Invitation To Bid: IFB-02-ENG-2019
Upgrade of the Northern District Wastewater Treatment Plant
GWA Project No. S17-003-OEA

Addendum No.: 06

Date: May 8, 2019

Response No. 9 to Step 2 Contractor Inquiries

Sheet: **A0.7**
637 OF 1075

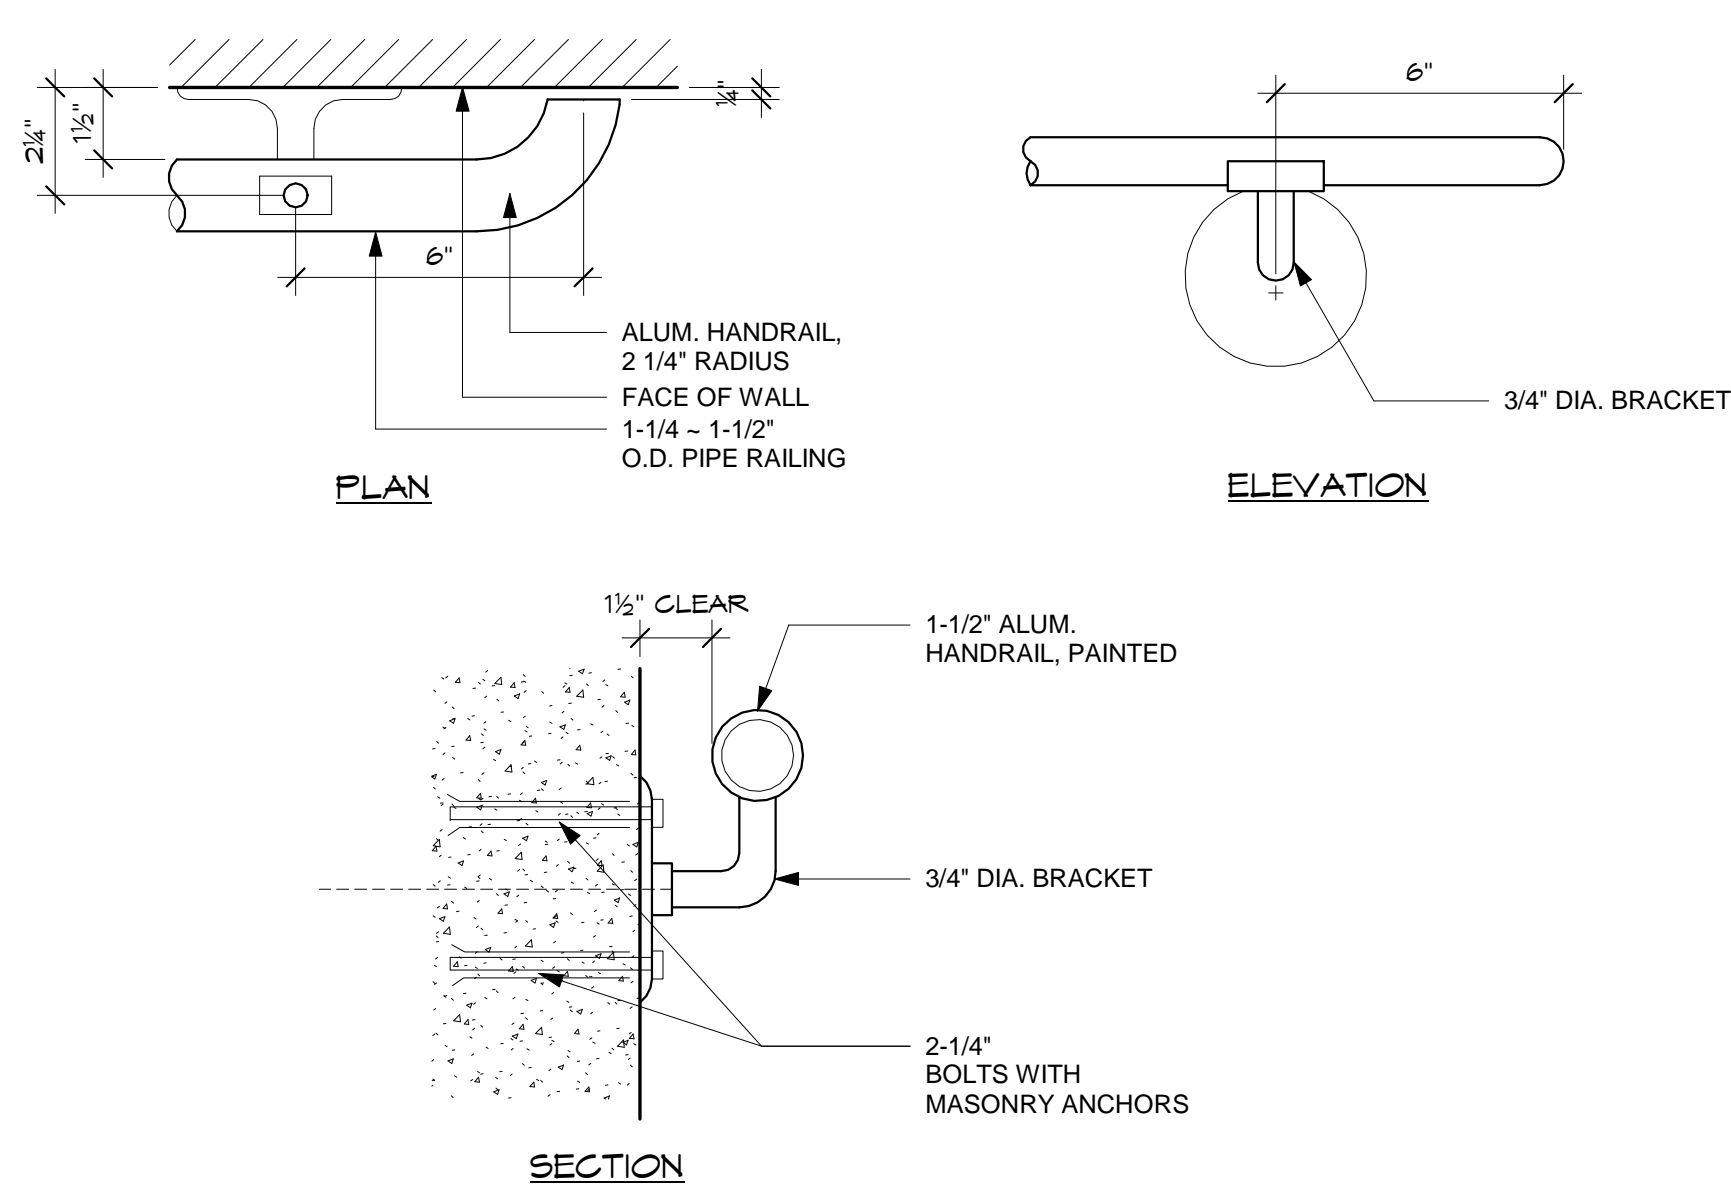
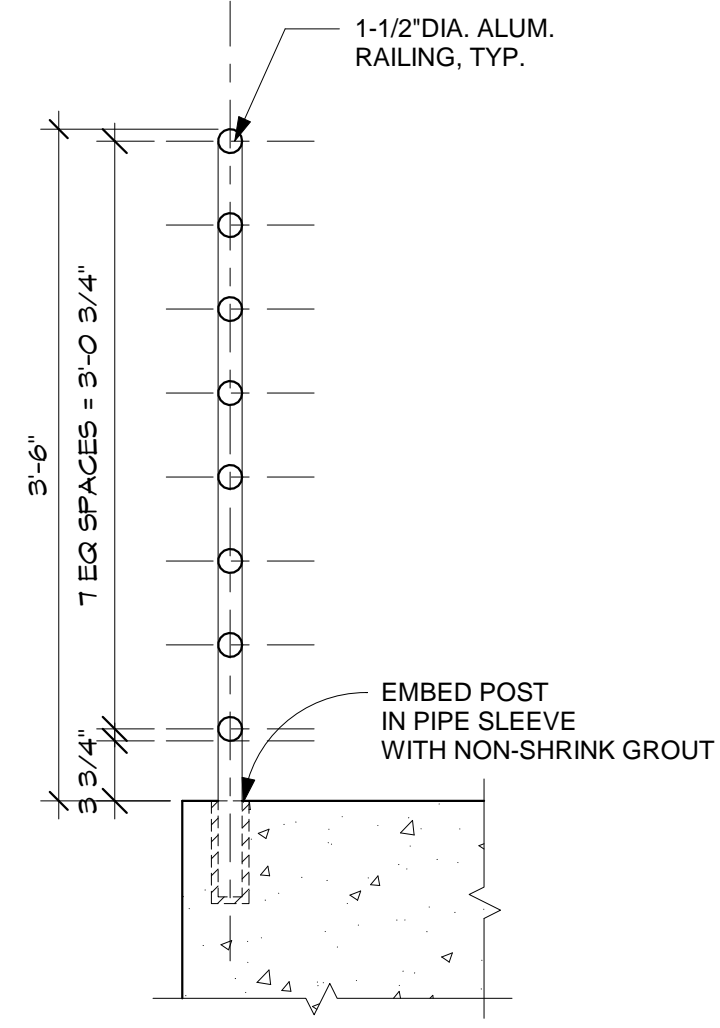
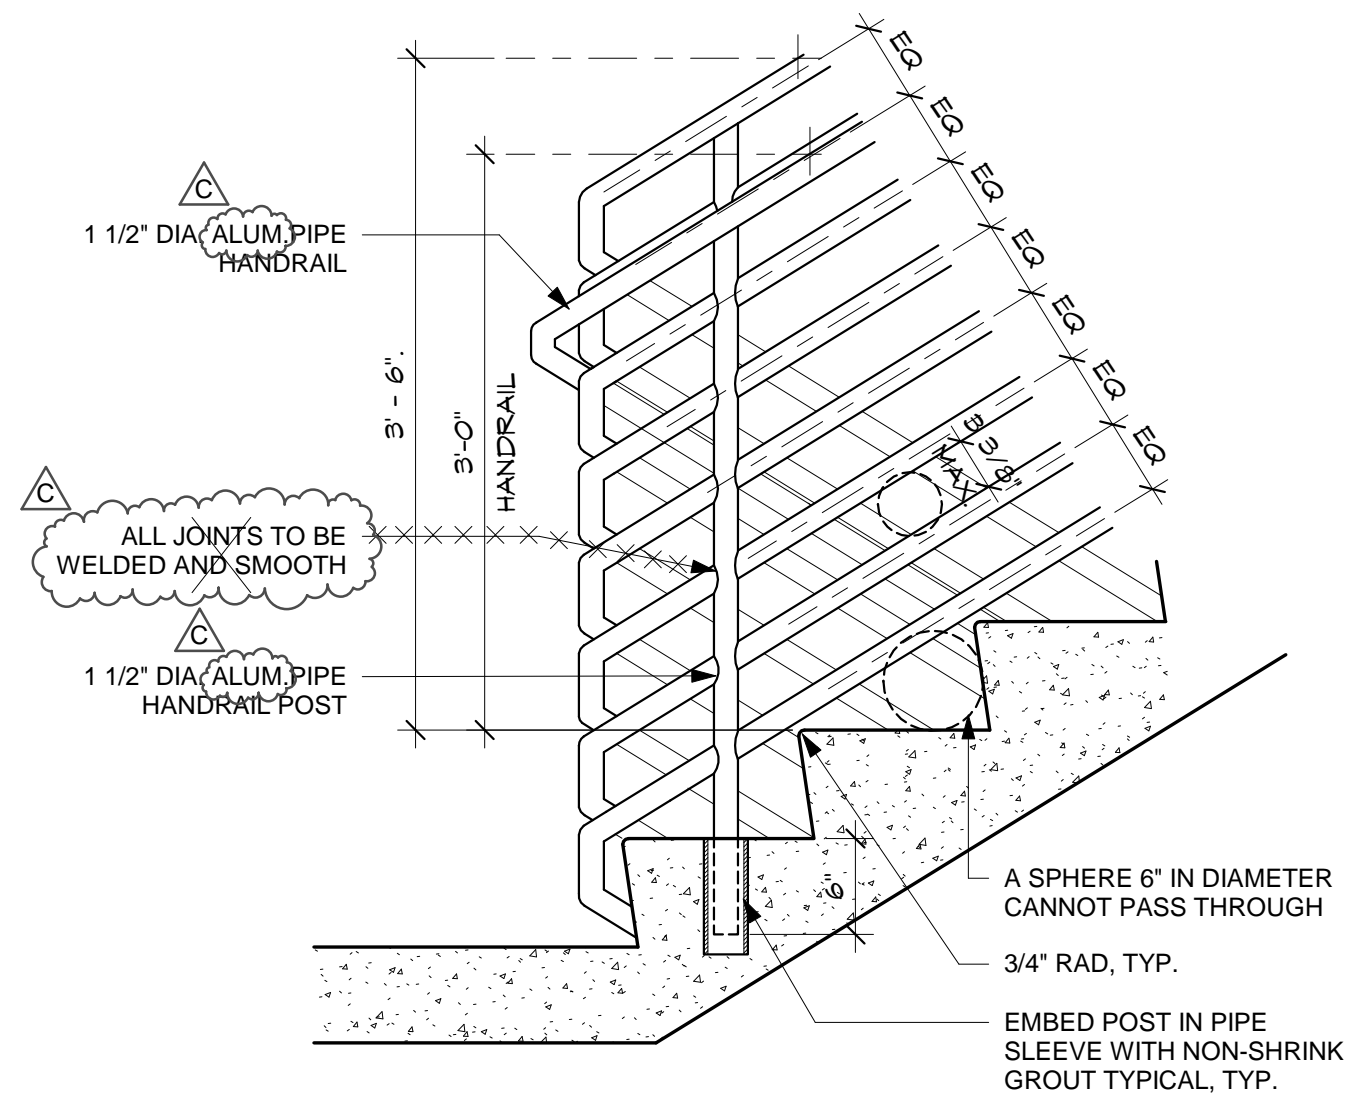
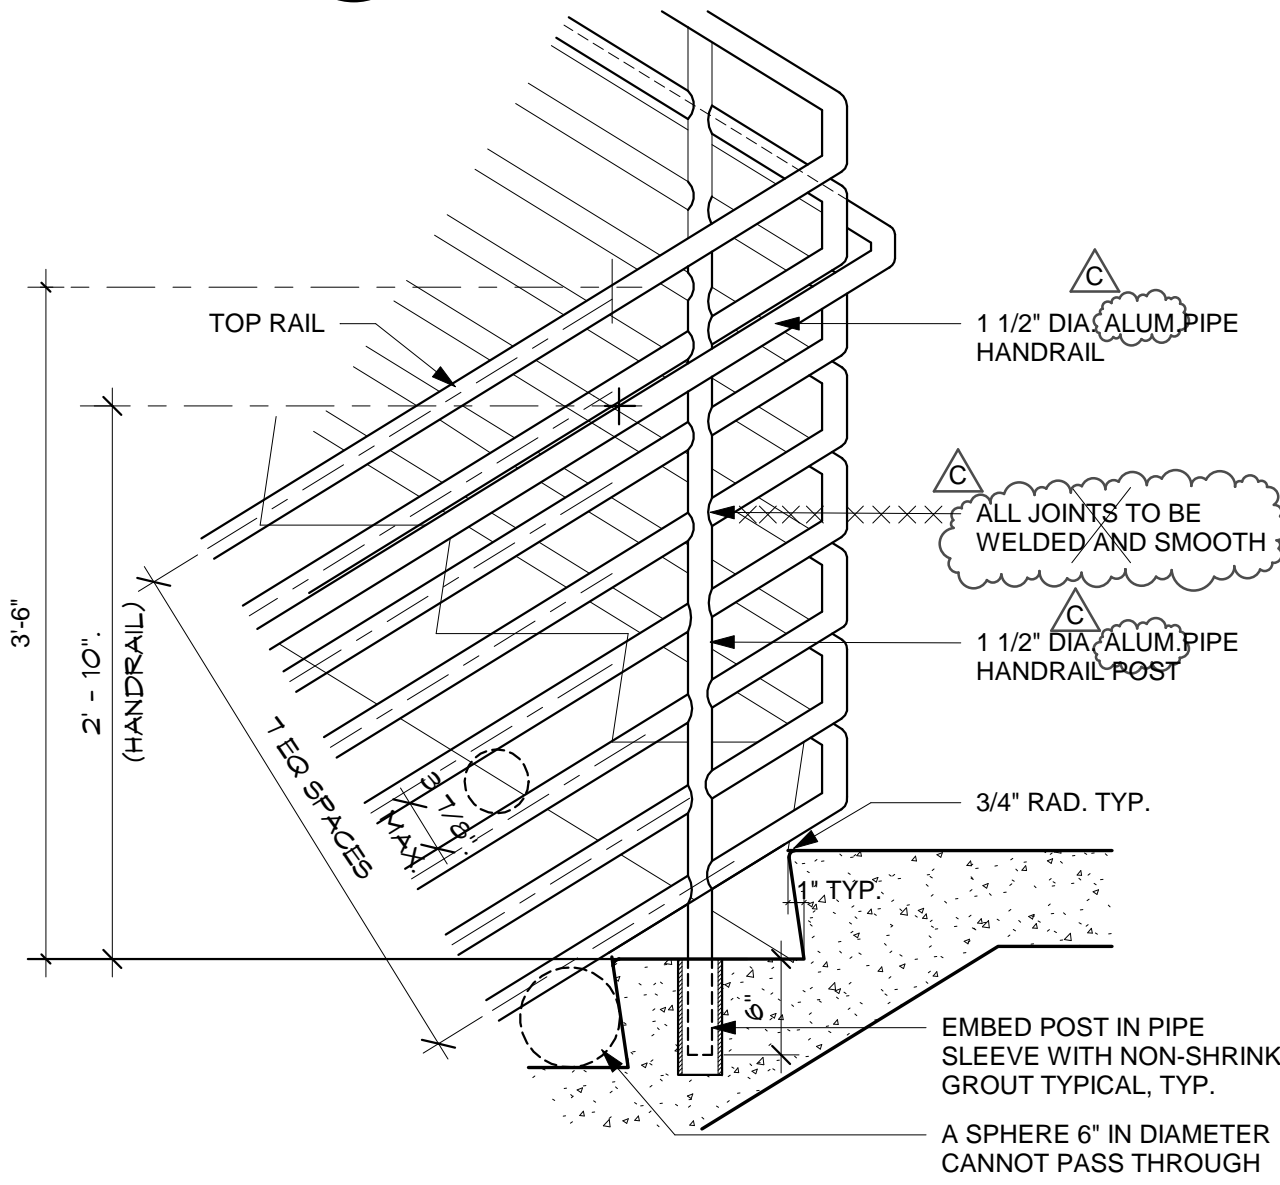
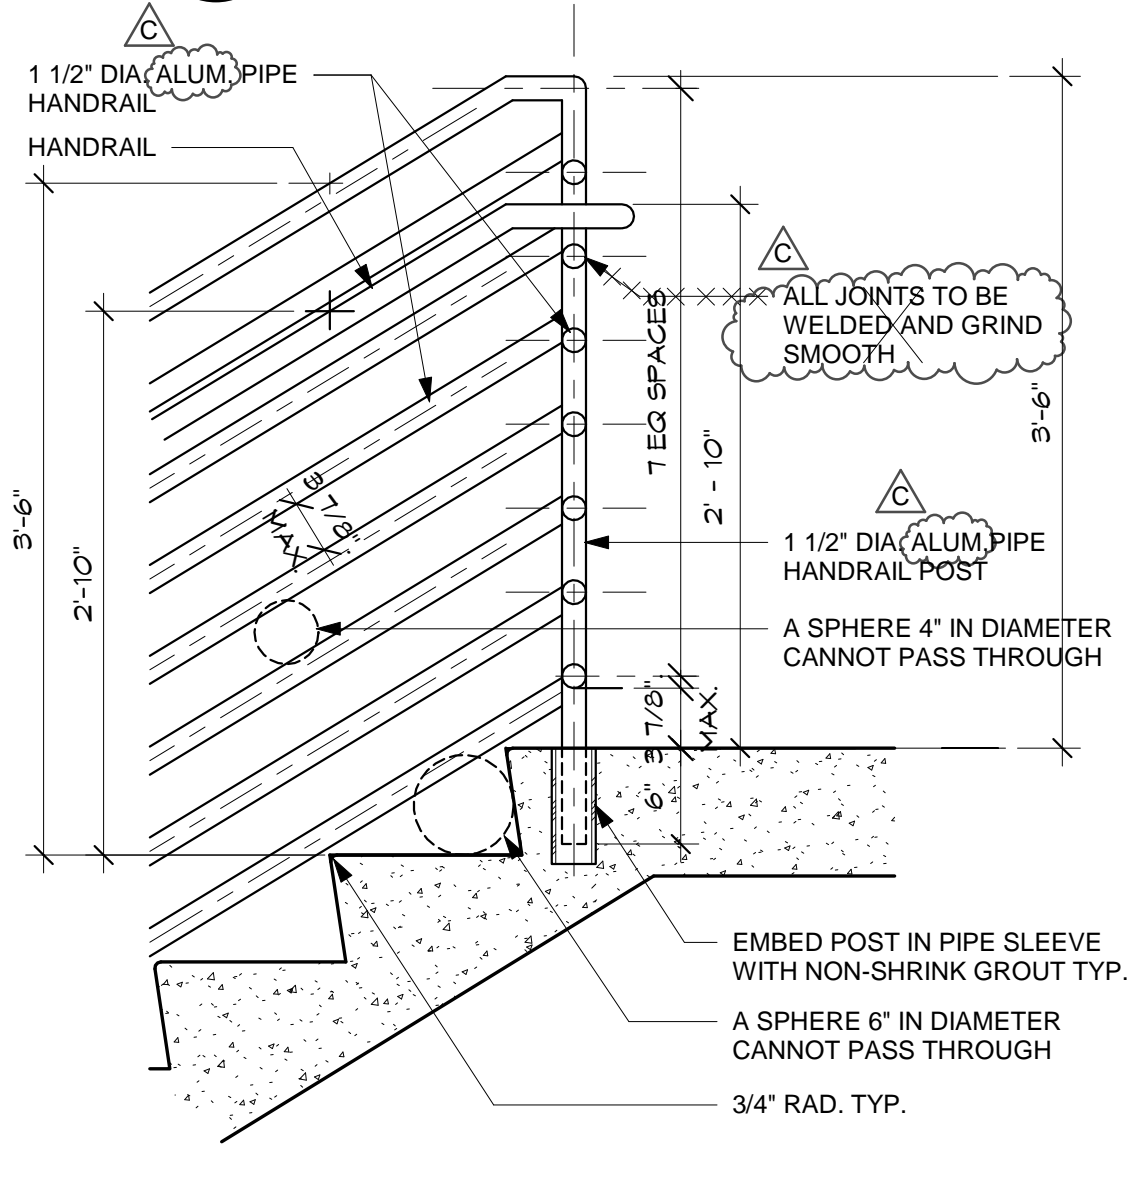
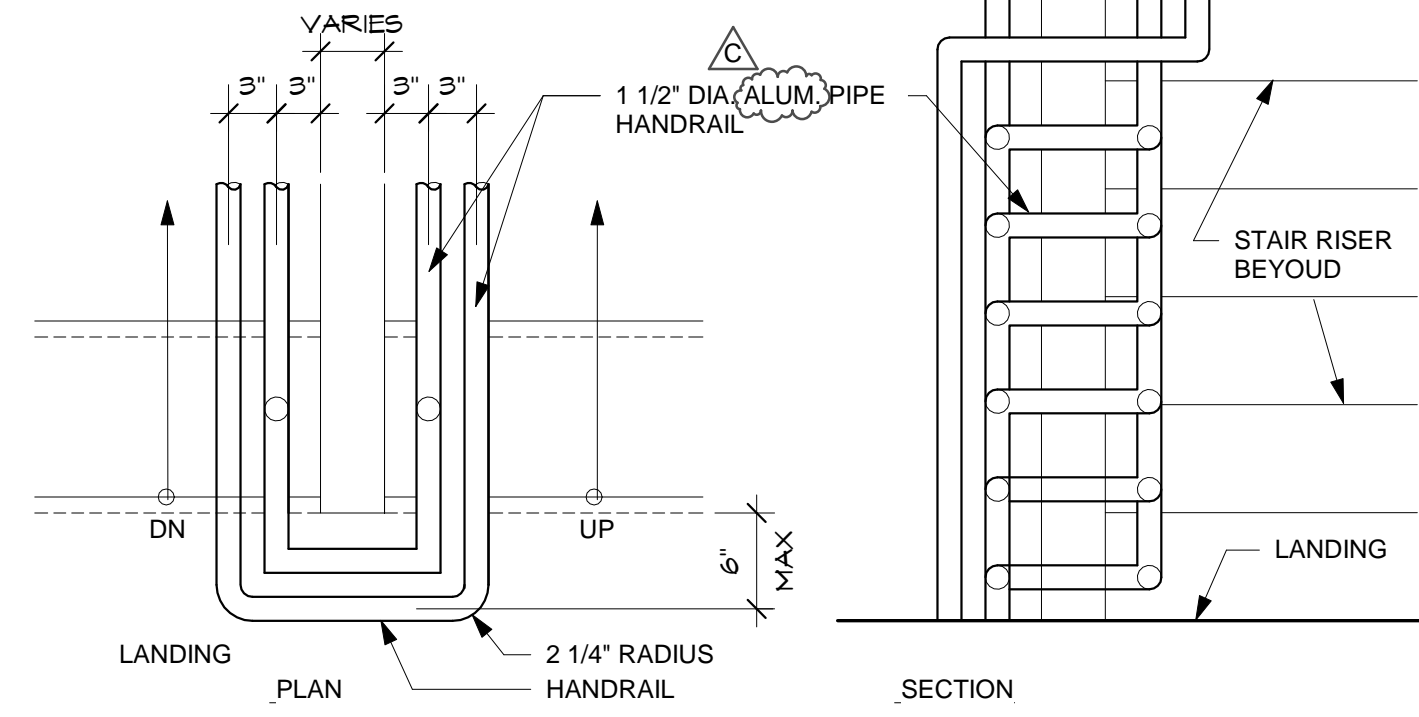
30i	Sheet A0.7	Please confirm that all railings and handrailing are to be made of aluminum as per Railing Details on sheet A0.7.	All handrails and railings are aluminum. See attached drawings A0.7.

32a	Sheet A0.7 and Section 055823	Details 5, 6, 7, & 9 on A0.7 indicate welded aluminum railings ("all joints to be welded and grind smooth") whereas aluminum railing spec 055823, 2.3, B provides for non-welded rail connections. 3.3, F also indicates "mechanical or adhesive joiner method and fittings." Please clarify that the railings are to be welded connection.	Refer to answered Item 30i.
32b	Aluminum Handrail	Bidder Question 20d on Response 7 indicated the railing finish to be siliconized powder coating. Please confirm if AAMA 2603, 2604, or 2605 criteria. Also, will primer coat be required?	Aluminum Railing is a clear anodized finished.
